REMARKS

In the final office action, the drawings were objected to under 37 C.F.R. § 1.83(a). The applicant submits new FIGS. 1-3 are submitted herewith as Replacement Sheets, with the amendments shown in red in the attached Annotated Sheets Showing Changes.

Figure 1

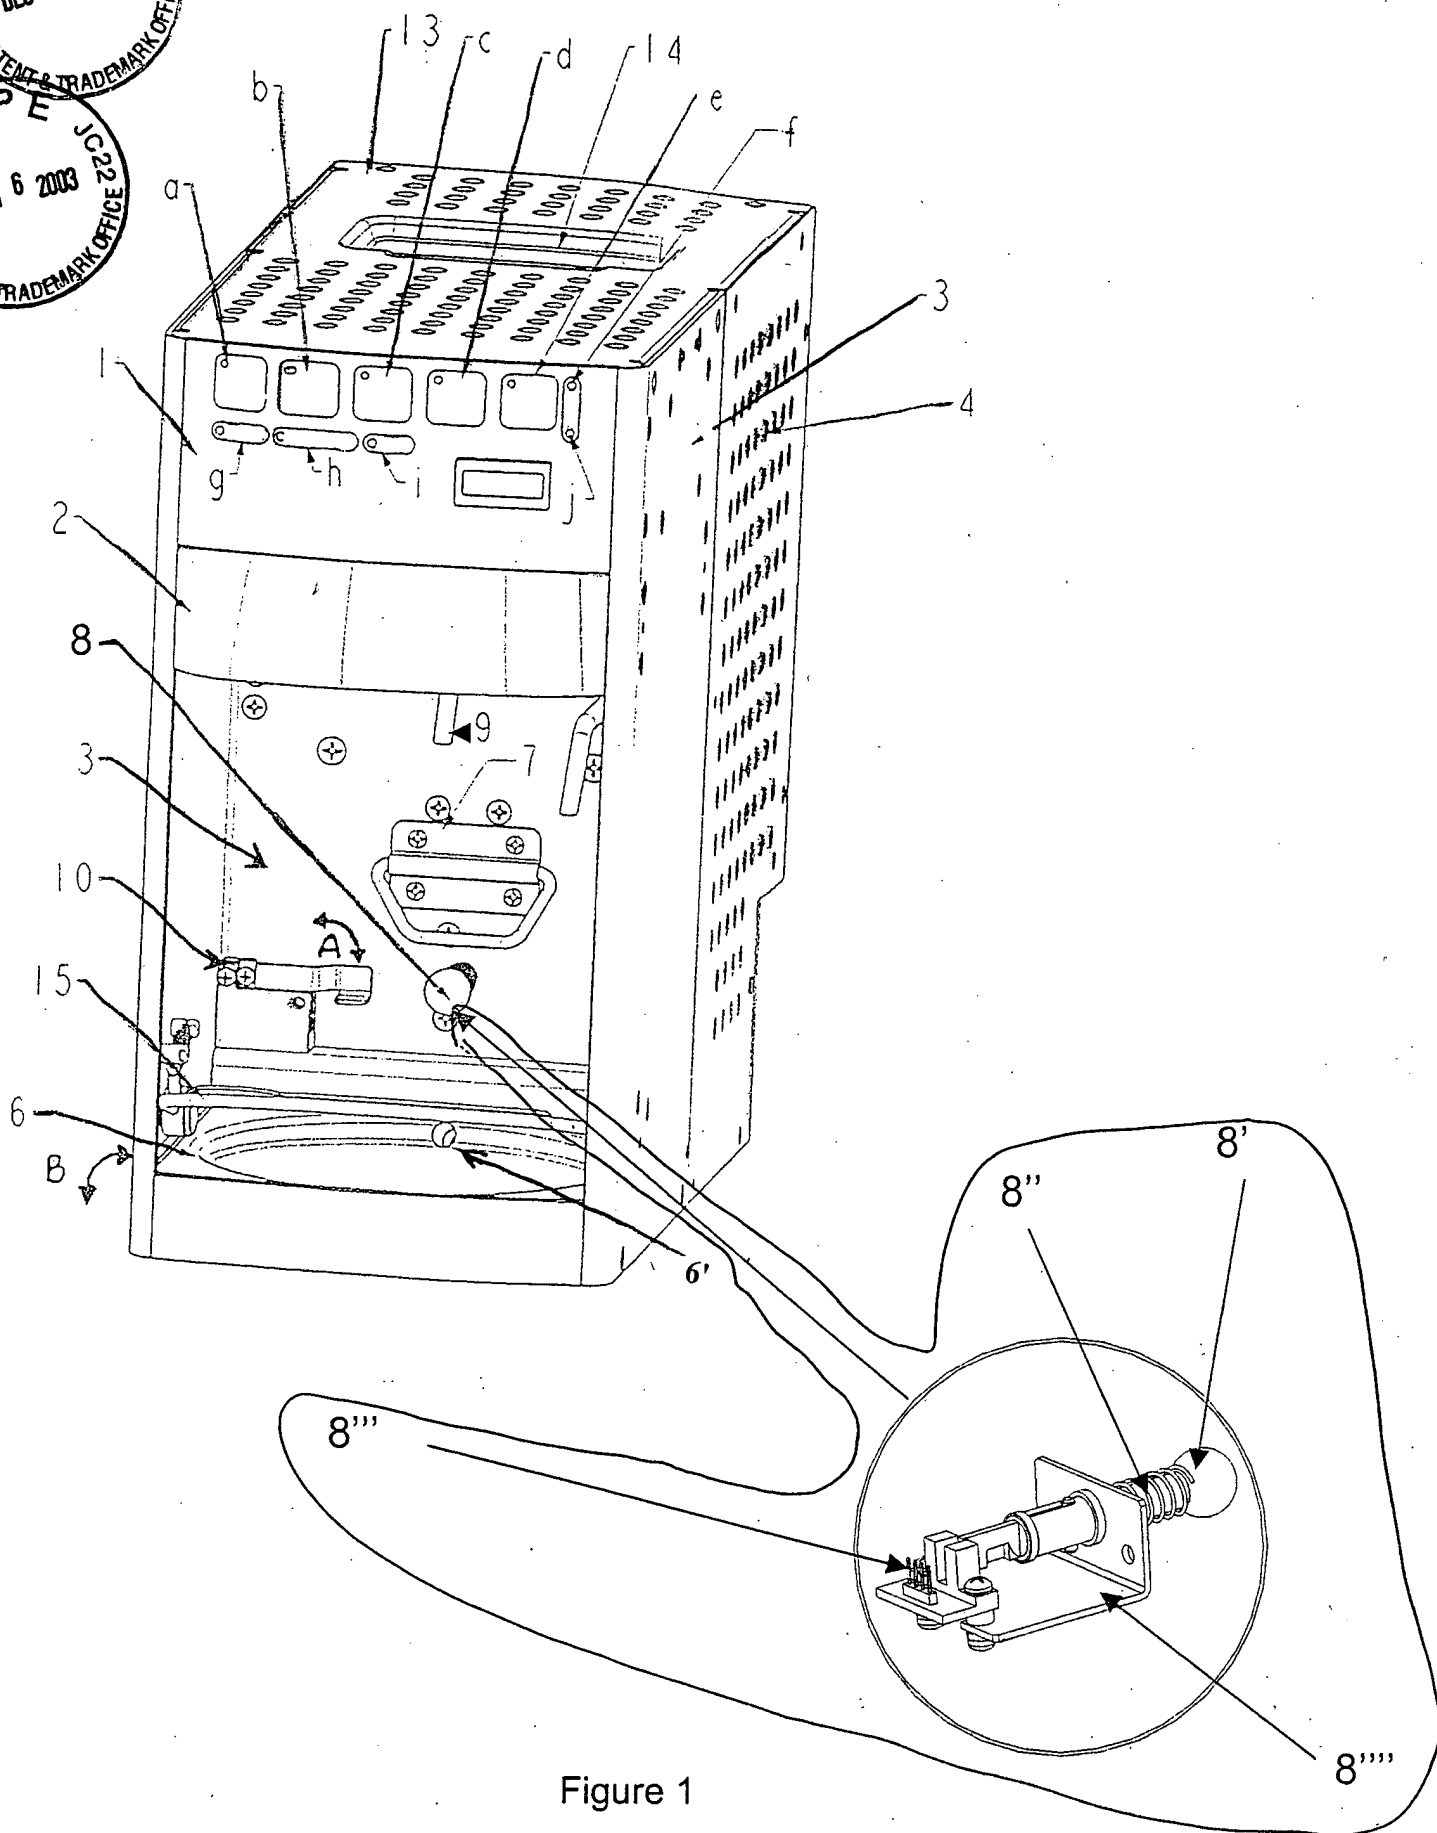
In the new drawings, the hydraulic actuation system is the hydraulic piston 114 shown in FIG. 3, as recited in claim 45; the spring sensor 8 is shown in FIG. 1, as recited in claim 49; the load cell system is shown as a load cell 6" in FIG. 2, as recited in claim 53; the filtering system is shown as the electromagnetic interference filtering system 19' in FIG. 2, as recited in claim 66; the filter is shown as a water filter 18' in FIG. 2, as recited in claim 68; and the serial port 16' is shown in FIG. 2, as recited in claim 71.

Figure 2

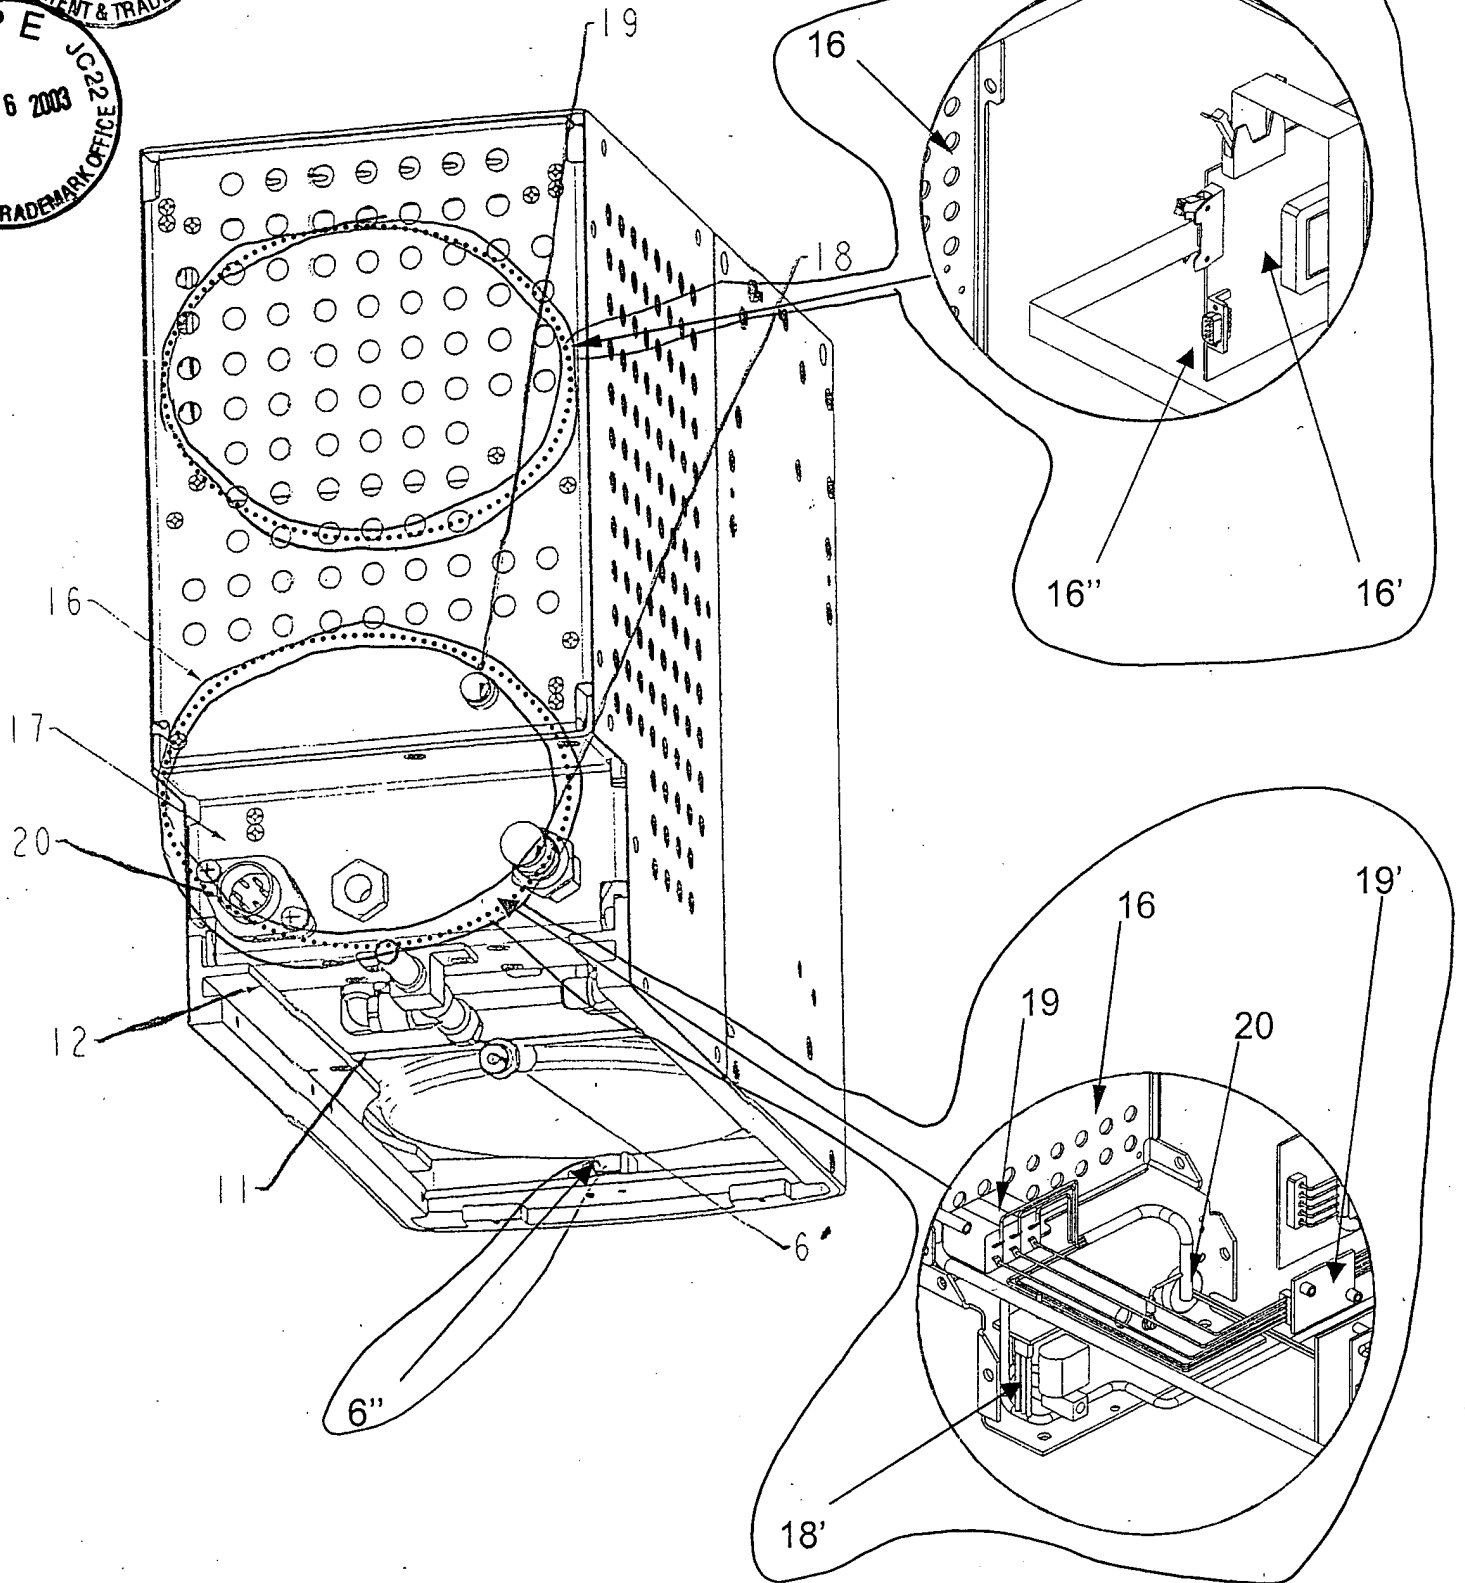
In addition, the flow of water which passes through the heater originates from the opening and closing of the electrovalves 104, 110, 111, and 112 (see FIG. 10), which allow the water coming from the aircraft to enter into the machine through element 18 (see in particular FIG. 2 in combination with FIG. 10), to operate the hydraulic piston, to enter into the heater, and eventually to be dispensed.

Figure 3

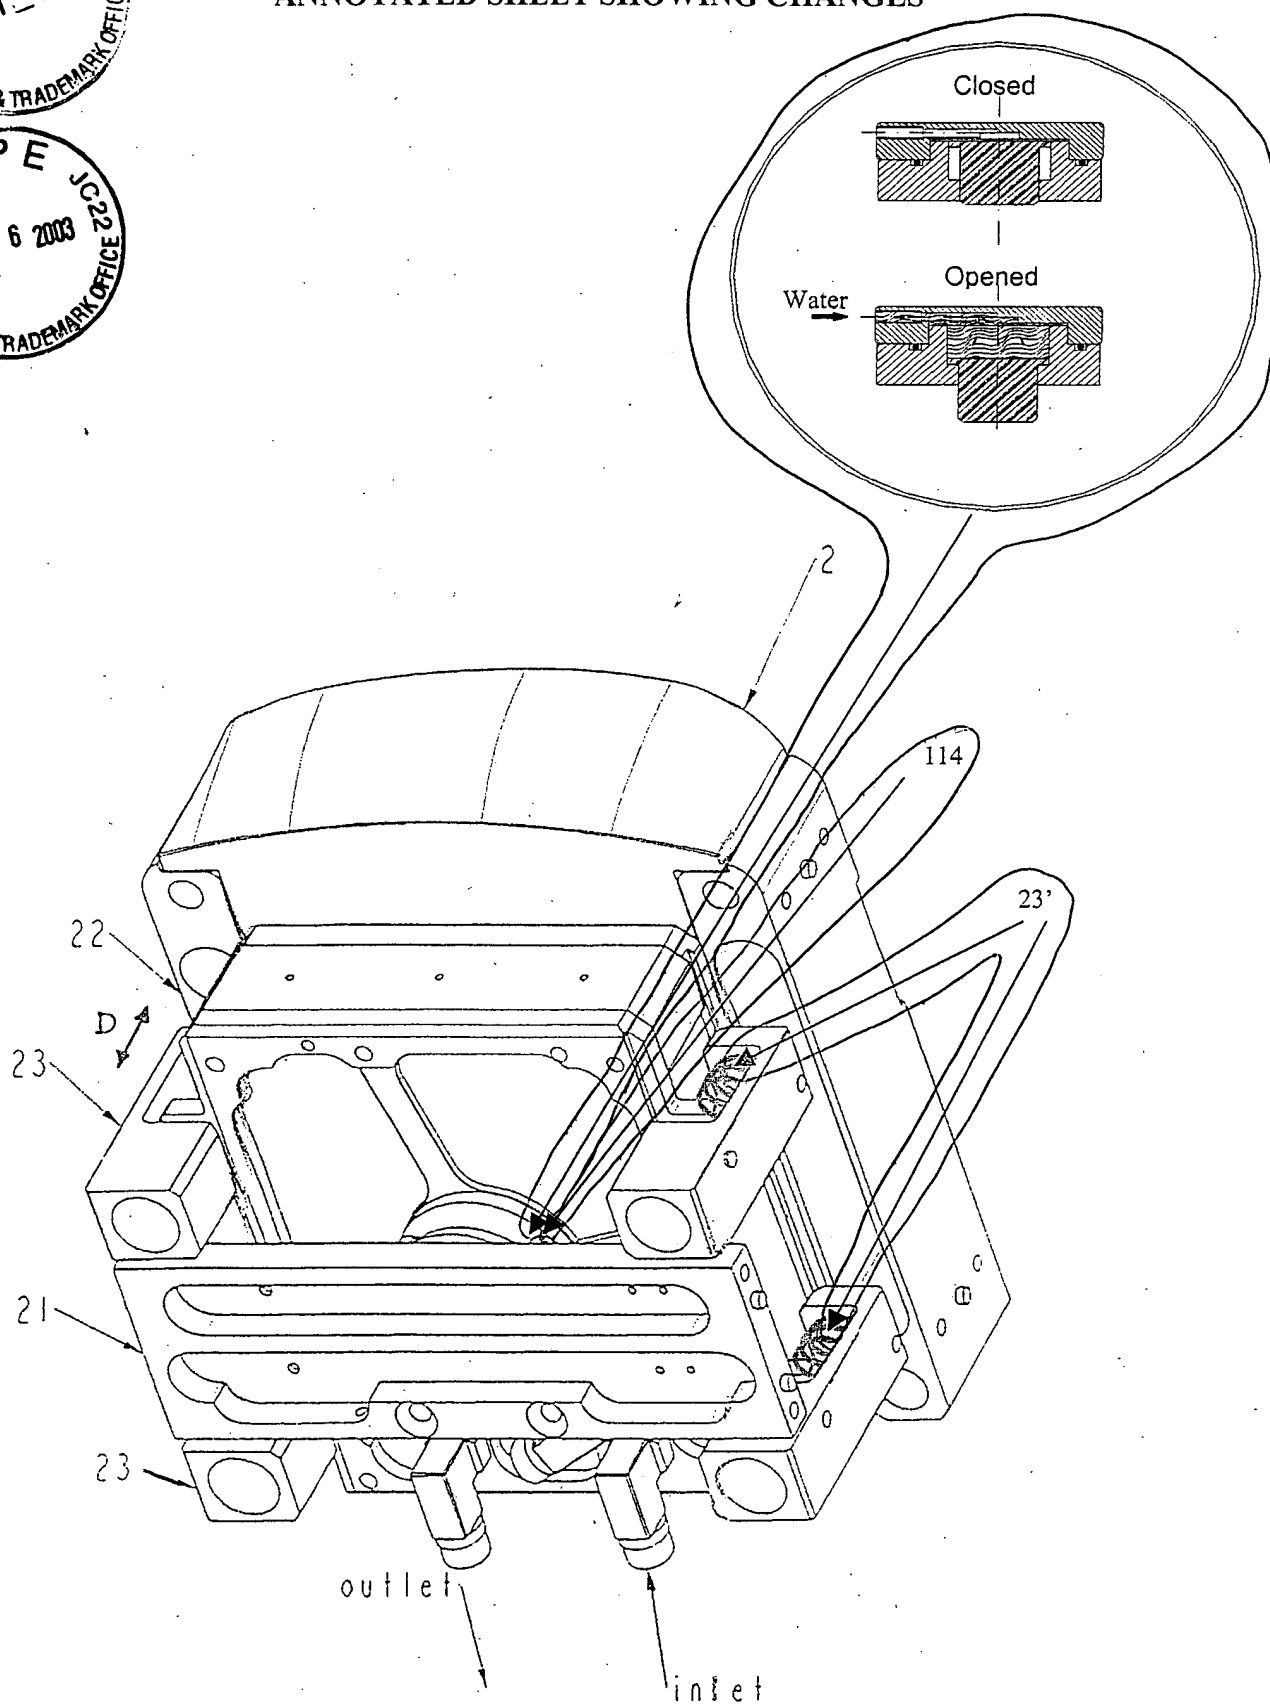
The "hydraulic actuation system" recited in claim 45 is described on page 10, lines 13-20 in combination with FIG. 10 in connection with a hydraulic piston for moving the exchanger 22 in the direction of the double-headed arrow D along travel guides 23 shown in FIG. 3. The hydraulic actuation system is operated by the pumps that push the water into the hydraulic piston 114, so that, when the pressure is present, is in its open position. When the pressure is absent, the hydraulic piston is in its closed position, with two solenoid valves or electrovalves 112 and 113 being provided.
